PCI-SIG ENGINEERING CHANGE NOTICE

| TITLE: | Completion Timeout Control Capability |
| AFFECTED DOCUMENT: | PCI Express Base Specification Revision 1.1 |

Figure 7-XX: Device Capabilities 2 Register

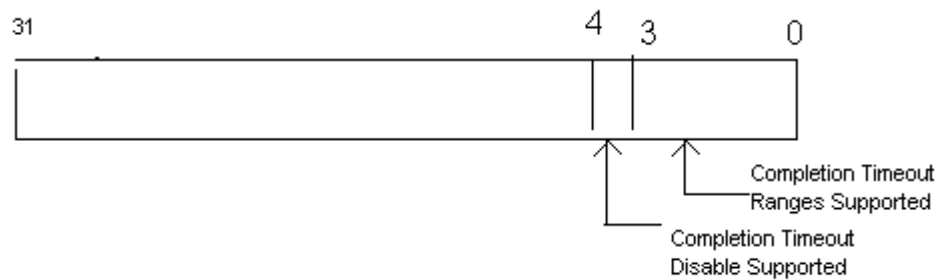
Building upon the PCI Express Capability Structure Expansion ECR/ECN, in Device Capabilities 2 and Device Control 2 Register sections, change as shown:

~~This section is a placeholder—There are no capabilities that require this register.~~

| Bit Location | Register Description | Attributes |
|--------------|---|------------|
| 3:0 | <p>Completion Timeout Ranges Supported – This field indicates device support for the optional Completion Timeout programmability mechanism. This mechanism allows system software to modify the Completion Timeout value.</p> <p>This field is applicable only to Root Ports, Endpoints that issue requests on their own behalf, and PCI Express to PCI/PCI-X Bridges that take ownership of requests issued on PCI Express. For all other devices this field is reserved and must be hardwired to 0000b.</p> <p>Four time value ranges are defined:</p> <p>_____ Range A: 50us to 10ms</p> <p>_____ Range B: 10ms to 250ms</p> <p>_____ Range C: 250ms to 4s</p> <p>_____ Range D: 4s to 64s</p> <p>Bits are set according to the table below to show timeout value ranges supported.</p> <p>_____ 0000b _____ Completion Timeout programming not supported – the device must implement a timeout value in the range 50us to 50ms.</p> <p>_____ 0001b _____ Range A</p> <p>_____ 0010b _____ Range B</p> <p>_____ 0011b _____ Ranges A & B</p> <p>_____ 0110b _____ Ranges B & C</p> <p>_____ 0111b _____ Ranges A, B & C</p> <p>_____ 1110b _____ Ranges B, C & D</p> <p>_____ 1111b _____ Ranges A, B, C & D</p> <p>All other values are reserved.</p> <p>It is strongly recommended that the Completion Timeout mechanism not expire in less than 10ms</p> | HwInit |

| Bit Location | Register Description | Attributes |
|--------------|--|------------|
| <u>4</u> | <p><u>Completion Timeout Disable Supported</u> – A value of 1b indicates support for the Completion Timeout Disable mechanism.</p> <p>The Completion Timeout Disable mechanism is required for Endpoints that issue requests on their own behalf and PCI Express to PCI/PCI-X Bridges that take ownership of requests issued on PCI Express.</p> <p>This mechanism is optional for Root Ports.</p> <p>For all other devices this field is reserved and must be hardwired to 0b.</p> | <u>RO</u> |

Figure 7-XX: Device Control 2 Register

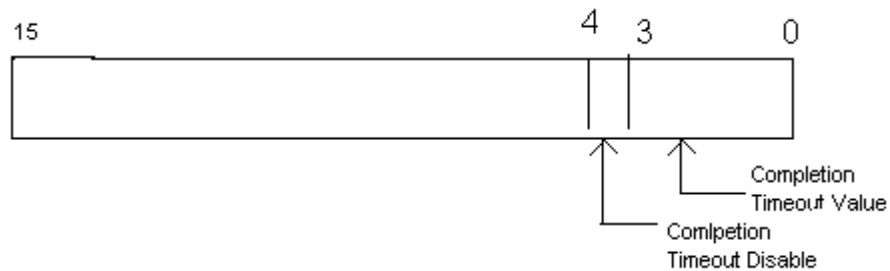
~~This section is a placeholder — There are no capabilities that require this register.~~

| Bit Location | Register Description | Attributes |
|--------------|---|------------|
| 3:0 | <p>Completion Timeout Value – In Devices that support Completion Timeout programmability, this field allows system software to modify the Completion Timeout value. This field is applicable to Root Ports, Endpoints that issue requests on their own behalf, and PCI Express to PCI/PCI-X Bridges that take ownership of requests issued on PCI Express. For all other devices this field is reserved and must be hardwired to 0000b.</p> <p>A Device that does not support this optional capability must hardwire this field to 0000b and is required to implement a timeout value in the range 50us to 50ms. Devices that support Completion Timeout programmability must support the values given below corresponding to the programmability ranges indicated in the Completion Timeout Values Supported field.</p> <p>Defined encodings:</p> <p>0000b Default range: 50us to 50ms</p> <p>It is strongly recommended that the Completion Timeout mechanism not expire in less than 10ms</p> <p>Values available if Range A (50us to 10ms) programmability range is supported:</p> <p>0001b 50us to 100us</p> <p>0010b 1ms to 10ms</p> <p>Values available if Range B (10ms to 250ms) programmability range is supported:</p> <p>0101b 16ms to 55ms</p> <p>0110b 65ms to 210ms</p> <p>Values available if Range C (250ms to 4s) programmability range is supported:</p> <p>1001b 260ms to 900ms</p> <p>1010b 1s to 3.5s</p> <p>Values available if the Range D (4s to 64s) programmability range is supported:</p> <p>1101b 4s to 13s</p> <p>1110b 17s to 64s</p> <p>Values not defined above are Reserved.</p> <p>Software is permitted to change the value in this field at any time. For requests already pending when the Completion Timeout Value is changed, hardware is permitted to use either the new or the old value for the outstanding requests, and is permitted to base the start time for each request either on when this value was changed or on when each request was issued.</p> <p>The default value for this field is 0000b.</p> | RW |

| Bit Location | Register Description | Attributes |
|--------------|--|------------|
| <u>4</u> | <p><u>Completion Timeout Disable – When set to 1b, this bit disables the Completion Timeout mechanism.</u></p> <p><u>This field is required for all devices that support the Completion Timeout Disable Capability.</u></p> <p><u>Software is permitted to set or clear this bit at any time. When set, the Completion Timeout detection mechanism is disabled. If there are outstanding requests when the bit is cleared, it is permitted but not required for hardware to apply the completion timeout mechanism to the outstanding requests. If this is done, it is permitted to base the start time for each request on either the time this bit was cleared or the time each request was issued.</u></p> <p><u>The default value for this bit is 0b.</u></p> | <u>RW</u> |
